Appl. No. : 09/379,704
Filed : August 24, 1999

COMMENTS

AMENDMENTS TO THE DRAWINGS

FIG. 5

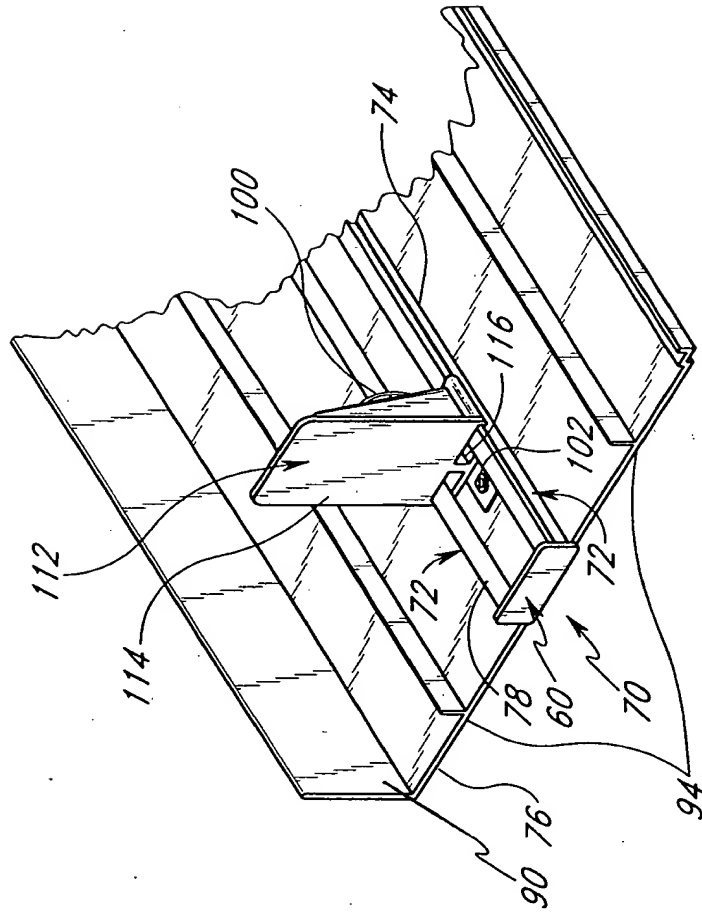
With respect to Figure 5, the lead line extending from the reference numeral 90 has been extended and the arrow head has been removed. Applicant submits, however, that reference numeral 76 is properly shown in the figure.

FIG. 1

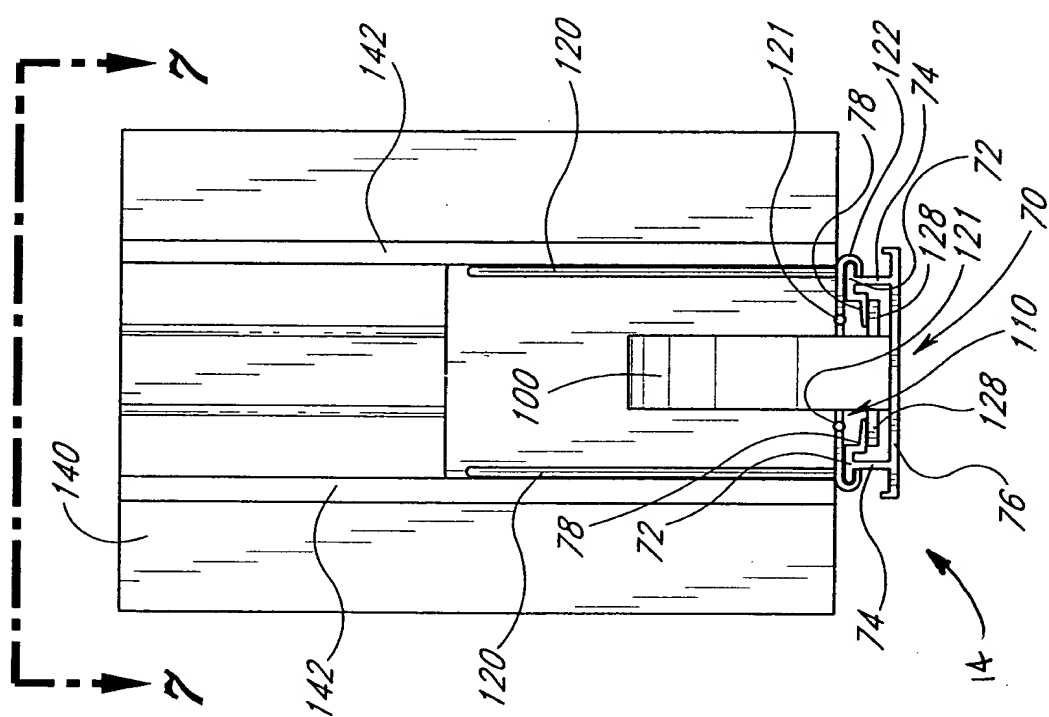
With respect to Figure 1, the extending ribs 94 have been added to the figure to make Figure 1 consistent with the rendering of Figures 2 and 3.

FIG. 8

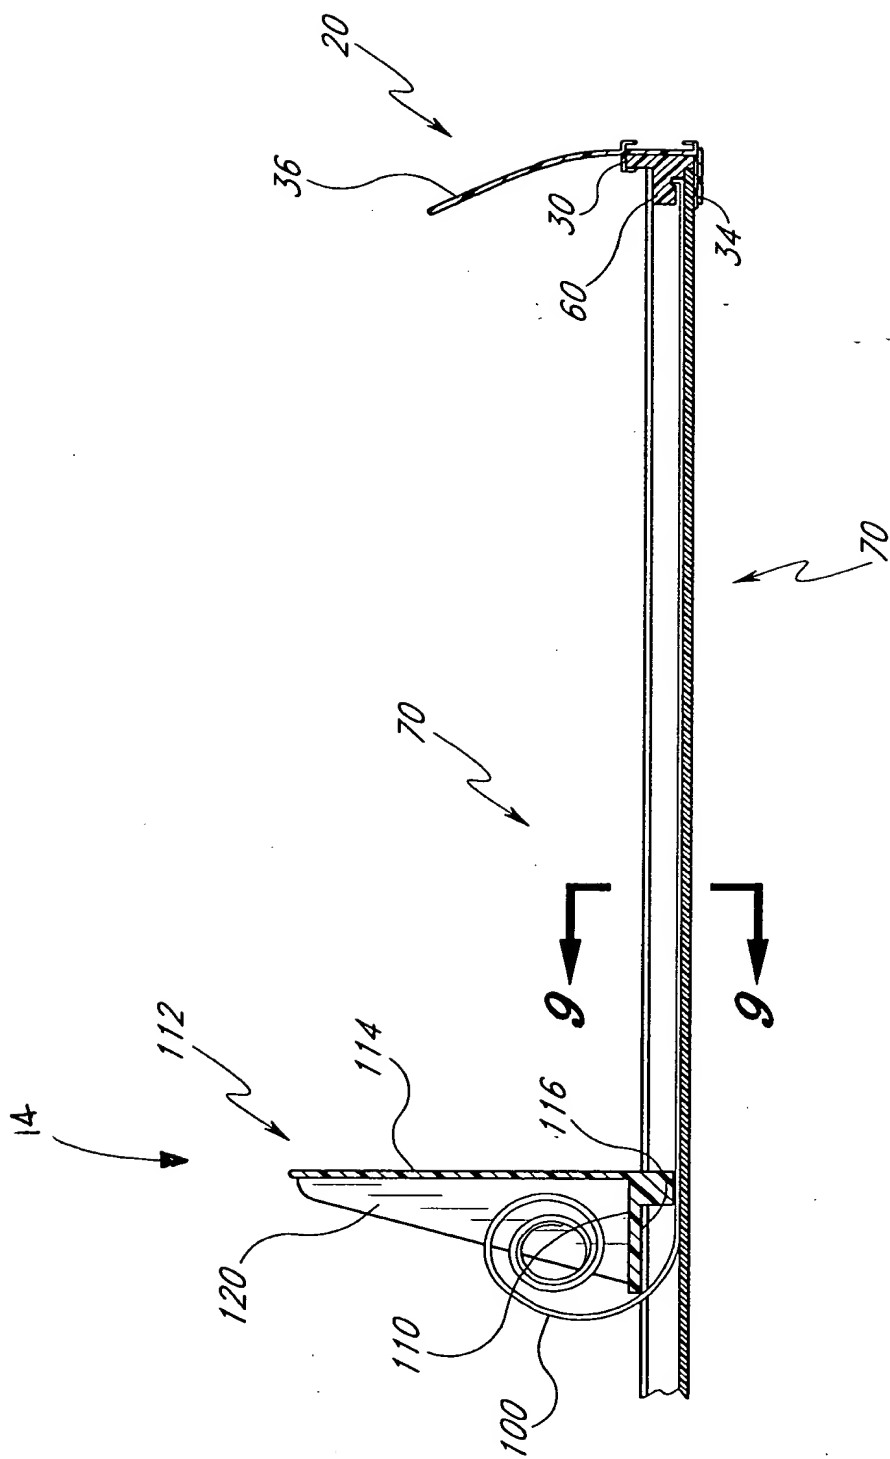
With respect to Figure 8, the rivet 102 is not shown in Figure 8 because Figure 8 illustrates another form of attaching the spring to the display system in which the spring is attached to the end clip.

With respect to Figures 6-8, the reference numeral 14 has been added to each of these figures for clarity.
